ADDENDUM 004

DATE: January 30, 2025
COMM NO: 24028
PROJECT: Crawford Hall Renovation - Roanoke College

TO: All Bidders
FROM: Earle Shumate
RE: Responses to Questions Received During Bidding

COMMISSION No. 24028
 SHEET A8-1

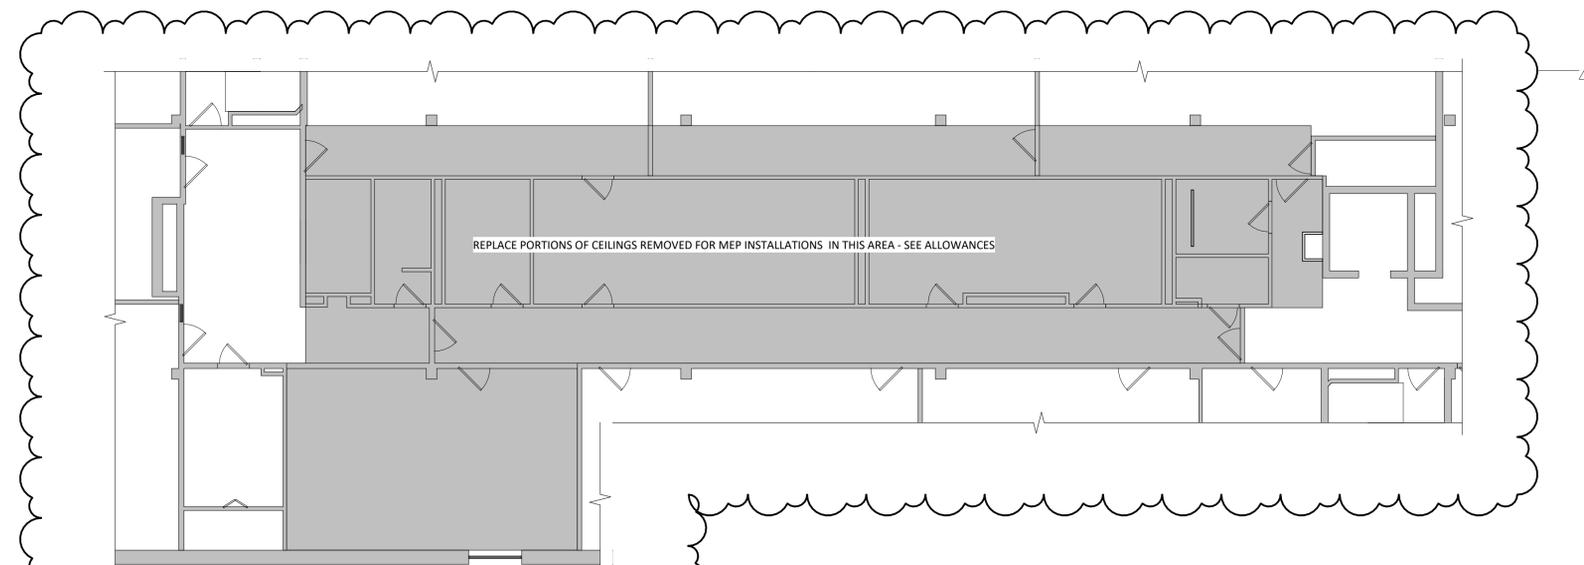
- Comment:** Minimize ceiling demolition in the basement as much as possible. Because the exact extent and scope of ceiling replacement cannot be determined at this time, disregard the revised reflected ceiling plan on Sheet A8-1 which was included in Addendum 003. Instead, include in the bid a stipulated cash allowance of \$20,000 for the repair or replacement of ceilings and re-installation of existing ceiling-mounted fixtures and devices. See revised specification Section 01 2100 – Allowances.

- A. Base Bid
 - 1. Include the stipulated sum of \$250,000 for mitigation of asbestos-containing materials
 - 2. Include the stipulated sum of \$25,000 for installation of fire alarm system detection and notification devices and wiring.
 - 3. Include the stipulated sum of \$400,000 for renovation of the existing elevator.
 - 4. Include the stipulated sum of \$20,000 for patching and replacement of portions of the basement ceiling demolished for utility installation. Allowance includes ceiling work and re-installation of ceiling-mounted fixtures and devices.

COMMISSION No.
 24028
 SHEET
E1-6

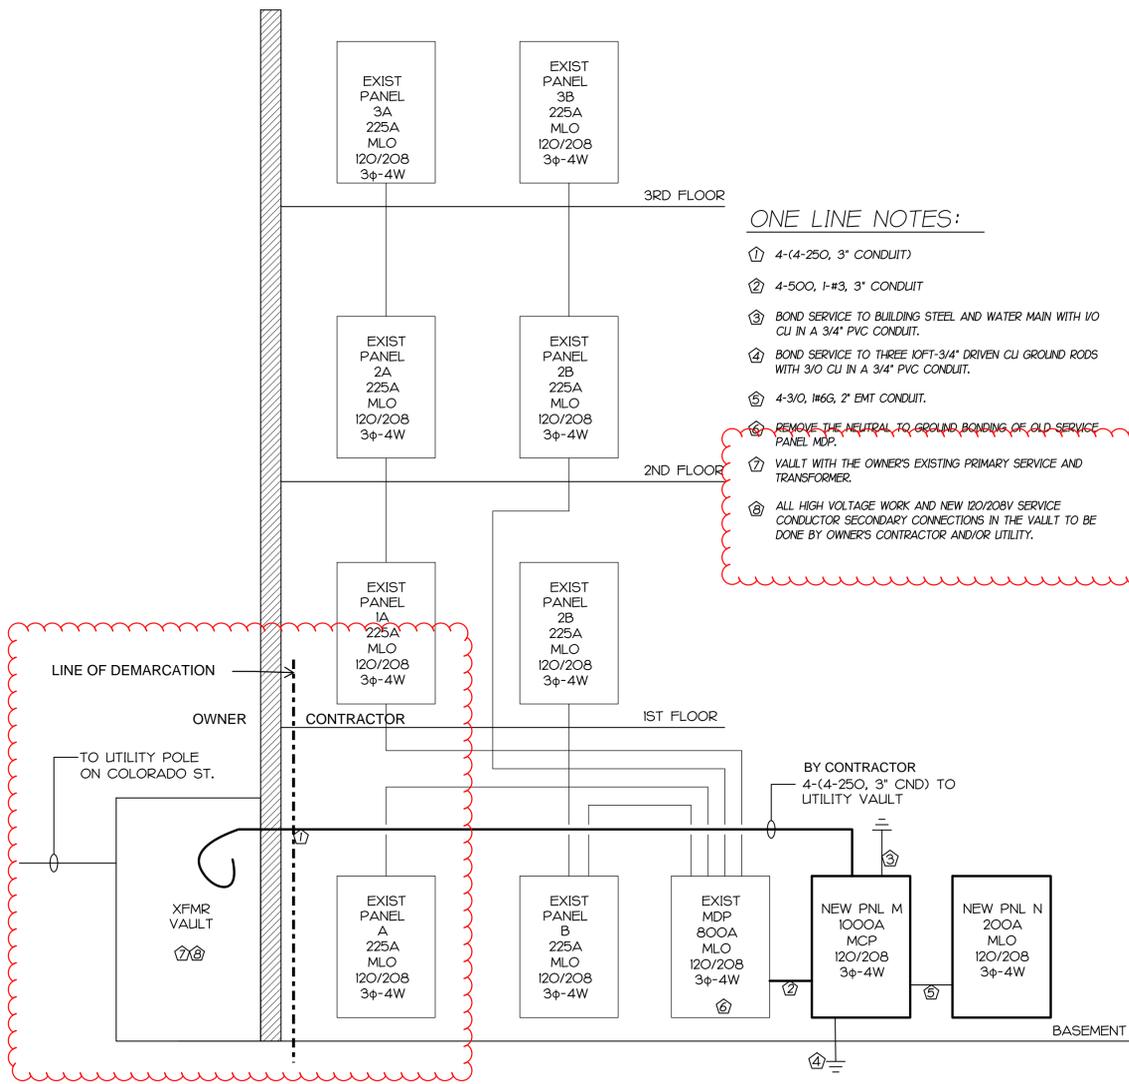
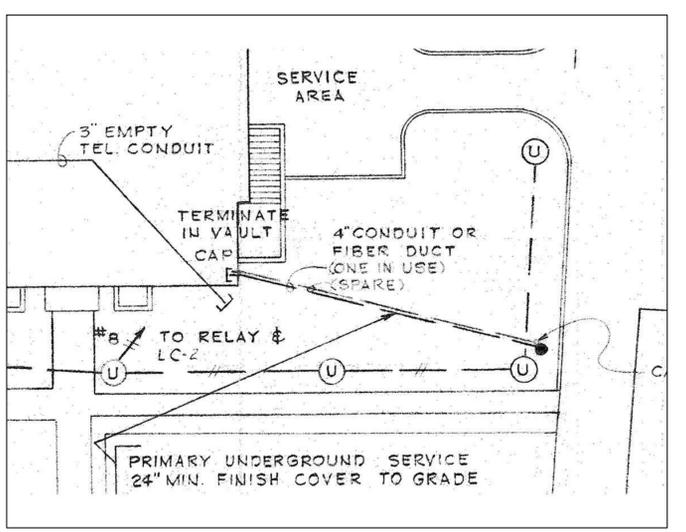
9. **Clarification:** Sheet E1-6 has been revised to indicate the scope of work related to the incoming electrical service. The Owner will provide new service from the utility pole into the Electrical Vault in the southwest corner of the building. The Owner will be responsible for exterior trenching, and removal and replacement of landscaping and pavement. The Owner will be responsible for all work inside the electrical vault including penetrations of the interior and exterior of the vault walls. The Contractor is responsible for installing the conduits between the MDP and the corridor side of the electrical vault wall, leaving space at the termination point for the Owner to cut and patch the wall and install a conduit extension into the vault. The Contractor is also responsible for providing the conductors from the MDP to the vault, leaving enough slack on the end of the conductors to allow the Owner to extend them into the vault and connect to the transformer. Closely coordinate work with the Owner.

- ONE LINE NOTES:
- 4-(4-250, 3" CONDUIT)
 - 4-500, 1-#3, 3" CONDUIT
 - BOND SERVICE TO BUILDING STEEL AND WATER MAIN WITH 1/0 CU IN A 3/4" PVC CONDUIT.
 - BOND SERVICE TO THREE 10FT-3/4" DRIVEN CU GROUND RODS WITH 3/0 CU IN A 3/4" PVC CONDUIT.
 - 4-3/0, 1#6G, 2" EMT CONDUIT.
 - REMOVE THE NEUTRAL TO GROUND BONDING OF OLD SERVICE PANEL MDP.
 - VAULT WITH THE OWNER'S EXISTING PRIMARY SERVICE AND TRANSFORMER.
 - ALL HIGH VOLTAGE WORK AND NEW 120/208V SERVICE CONDUCTOR SECONDARY CONNECTIONS IN THE VAULT TO BE DONE BY OWNER'S CONTRACTOR AND/OR UTILITY.
